METROPOLITAN AREA PLANNING COMMISSION

STAFF REPORT

CASE NUMBER: S/D 93-69 ABERDEAN ADDITION

Re: S/D 93-69 - ABERDEAN ADDITION (Final Plat)

ABERDEAN FIRST ADDITION

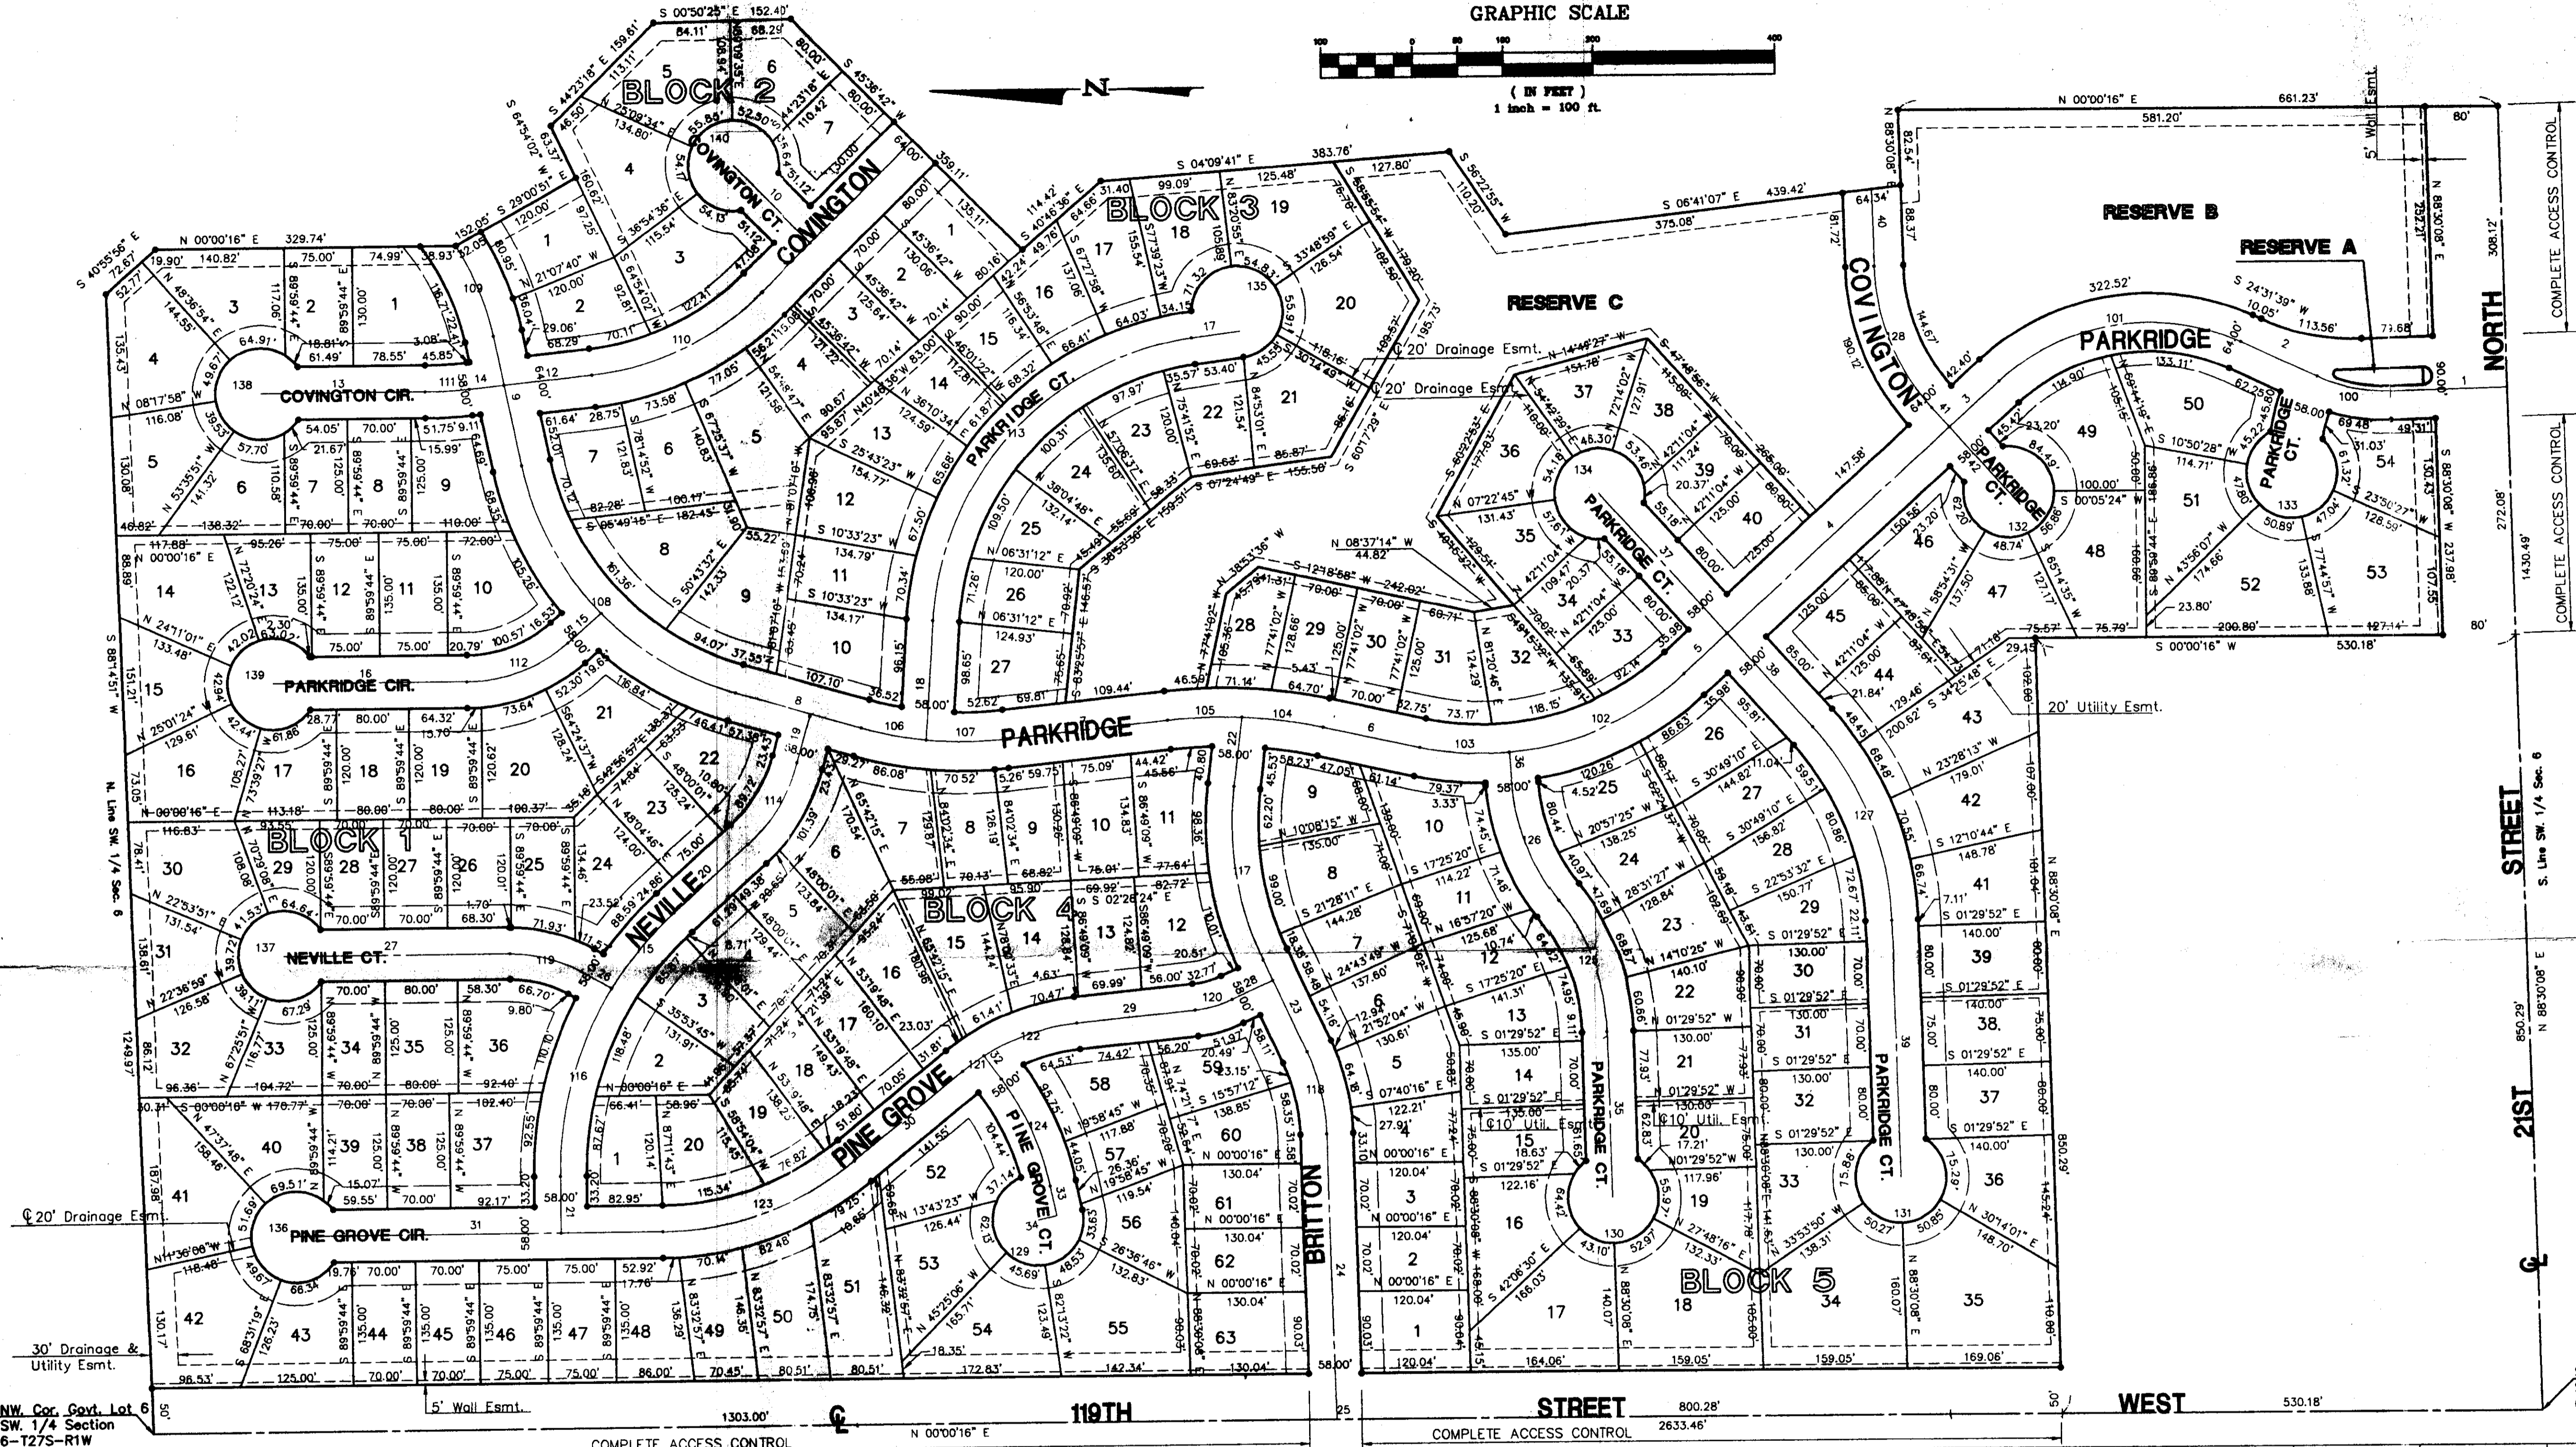
- Q. Since Parkridge is shown as ending as a Circle (cul-de-sac) toward the north line of this plat, the segment of street between the Circle (starting at Lot 10, Block 1) and the east line of this plat cannot be considered to also be a segment of Parkridge. Based on the overall sketch plat, this segment appears to be part of an east-west street and should be labeled with an appropriate street name.

The representative from the City's Fire Department should be contacted to determine an appropriate name for this east-west street or the segment of it as now being platted. The final plat tracing shall indicate this street name.

1. The reference to minimum building elevations shall note, both in the plat's text and on the face of the plat, the elevations in mean sea level (MSL) in addition to City Datum.

2. Easements and building setbacks shall also be appropriately labeled and identified on the face of the plat and not just referenced by a note. That is, without such labels it could be questionable if areas on certain lots or within Reserves include easements or setbacks and consequently such information needs to be explicitly shown.

3. The wall easement along the west line of Block 5 shall be labeled.
 4. Parkridge's (or the street segment to be named) right-of-way (64-ft.) shall also be indicated toward the north end of this street, i.e., between Lots 1 of Blocks 1 & 2.

5. Dashed lines should be used for the terminus of streets such as Covington and Parkridge (segment to be named) at this plat's east line. Solid lines are used to indicate private streets.

6. Solid letters and numbers shall be used to indicate Blocks. The open print now used is difficult to see.
 7. Sheet number 2 shall be labeled as "sheet No. 2 of 2". Now one sheet is labeled 1 of 2 while the other is shown as 1 of 1.

8. The MAPC signature block shall indicate James D. Miner as chairman.
 9. The County Clerk's signature block shall indicate Susan E. Crockett-Spoon.
- T. The applicant's engineer is advised that the Register of Deeds is requiring the name(s) of the notary public, who acknowledges the signatures on this plat, to be printed beneath the notary's signature.
